SUNDRY NOTICES AND REPORTS ON WELLS
Do not use this form for proposals to drill or to re-enter an abandoned well. Use Form 3160-3 (APD) for such proposals.

8. Well Name and No. **AMAZING 19 FED/703H**

EOG respectfully requests an amendment to our approved APD for this well to reflect the following changes:

Amazing 19 Fed 703H API #: 30-025-50479

WELL LOCATION AND ACREAGE DEDICATION PLAT

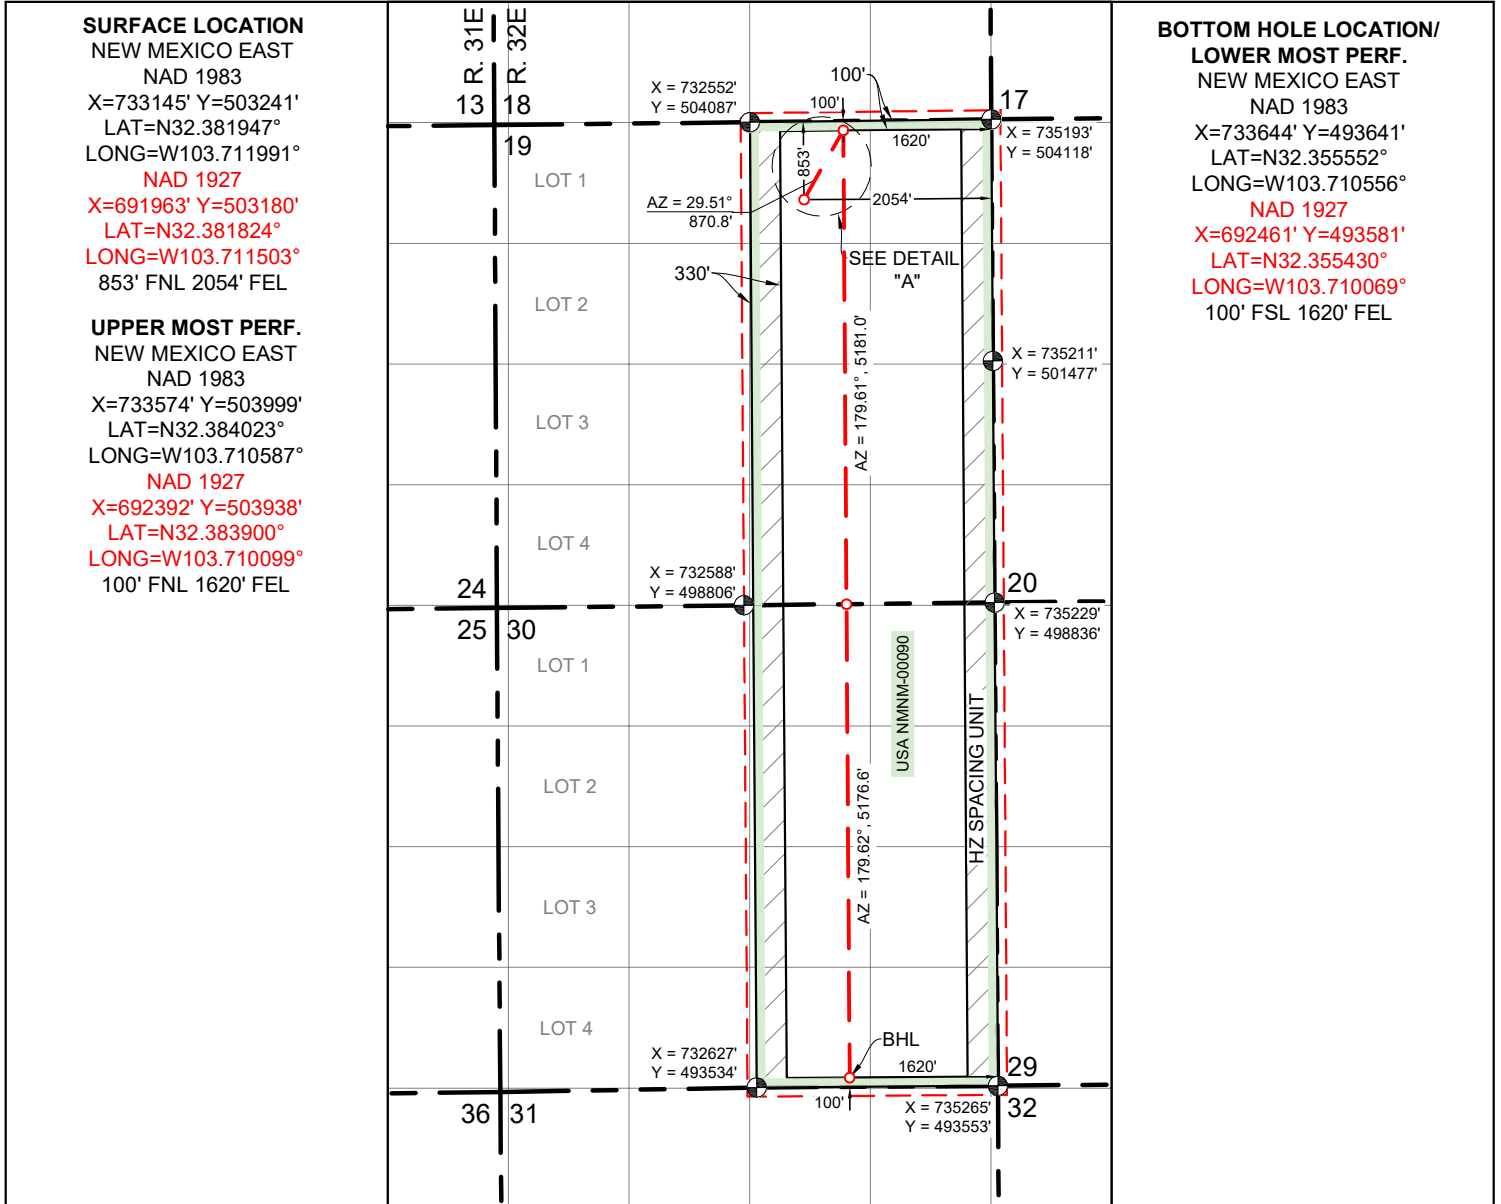
Change BHL from T-22-S, R-32-E, Sec 30, 100' FSL, 1650' FEL, Lea Co., NM, to T-22-S, R-32-E, Sec 30, 100' FSL, 1620' FEL, Lea Co., N.M.

UL or lot no.	Section	Township	Range	Lot Idn	Feet from the	North/South line	Feet from the	East/West line	County
O	30	22 S	32 E		100	SOUTH	1620	EAST	LEA

BOTTOM HOLE LOCATION/
LOWER MOST PERF.
NEW MEXICO EAST
NAD 1983
X=733644' Y=493641'
LAT=N32.355552°
LONG=W103.710556°
NAD 1927
X=692461' Y=493581'
LAT=N32.355430°
LONG=W103.710069°
100' FSL 1620' FEL

Proposed Wellbore

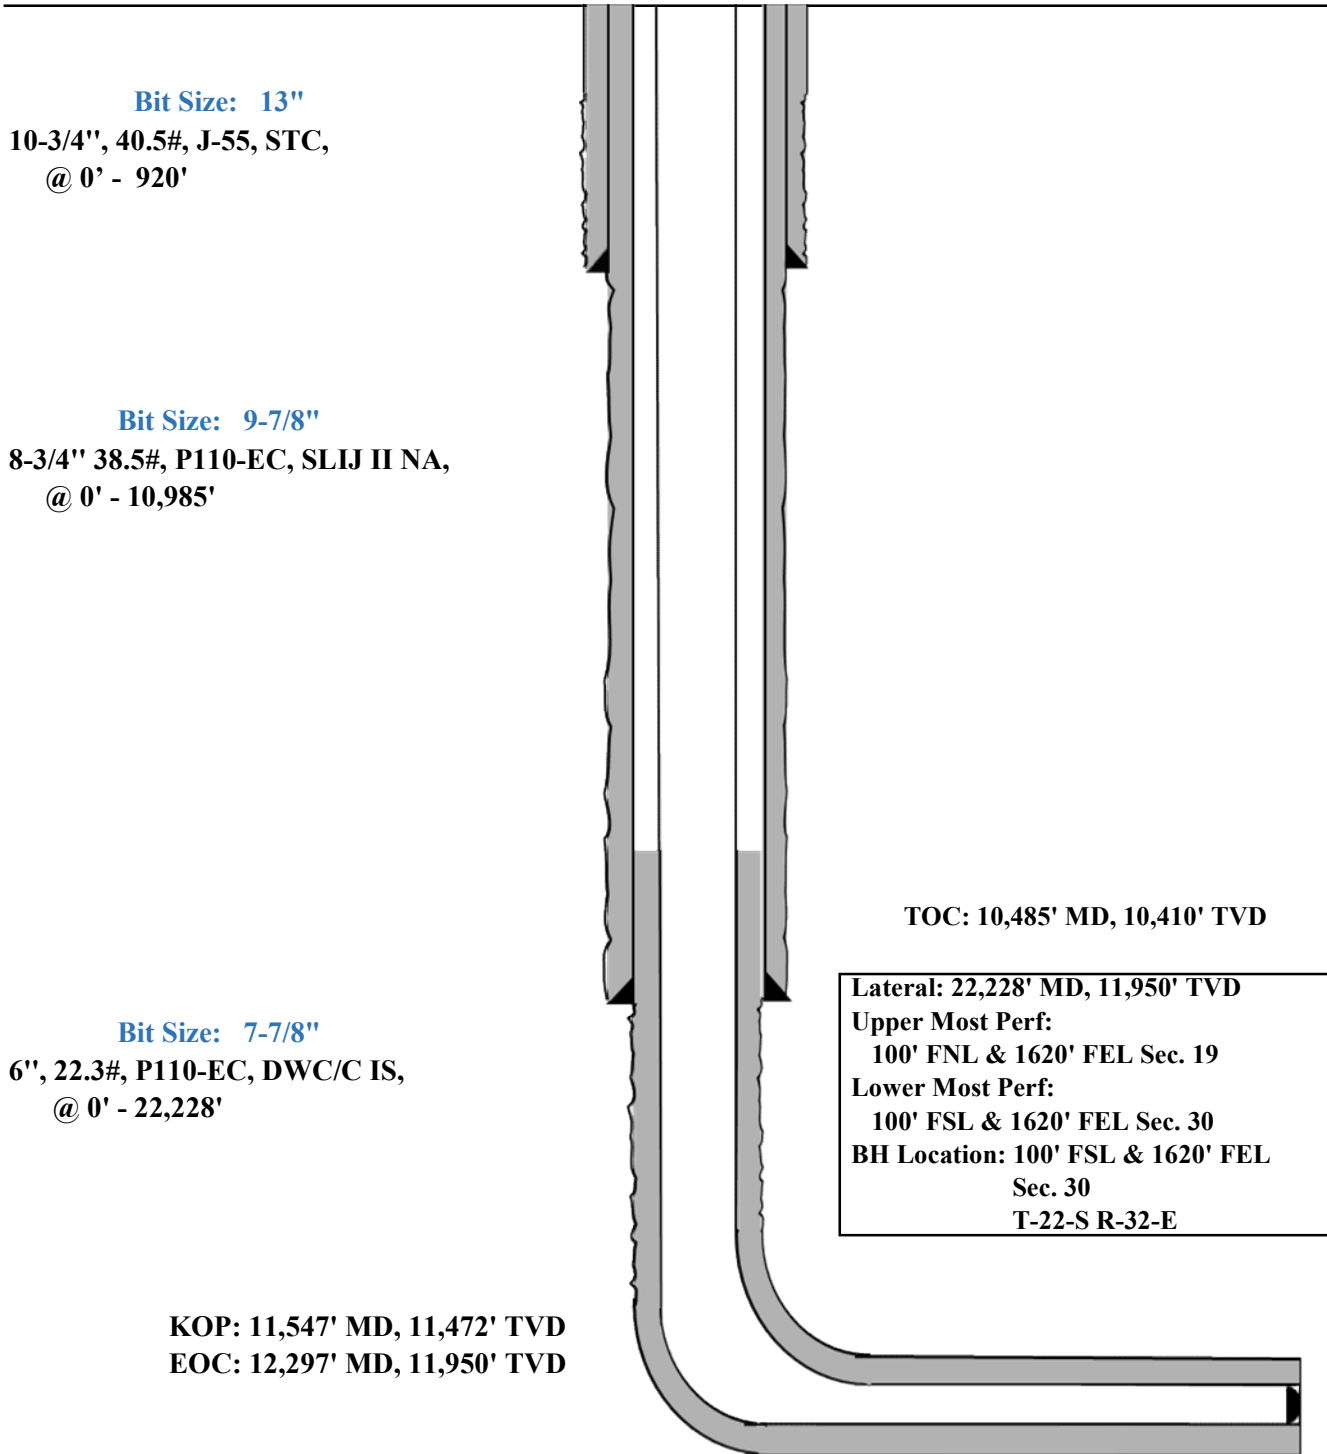
Update casing and cement program to current design.

Hole Size	Interval MD		Interval TVD		Csg OD	Weight	Grade	Conn
	From (ft)	To (ft)	From (ft)	To (ft)				
13"	0	920	0	920	10-3/4"	40.5#	J-55	STC
9-7/8"	0	10,985	0	10,910	8-3/4"	38.5#	P110-EC	SLIJ II NA
7-7/8"	0	22,228	0	11,950	6"	22.3#	P110-EC	DWC/C IS
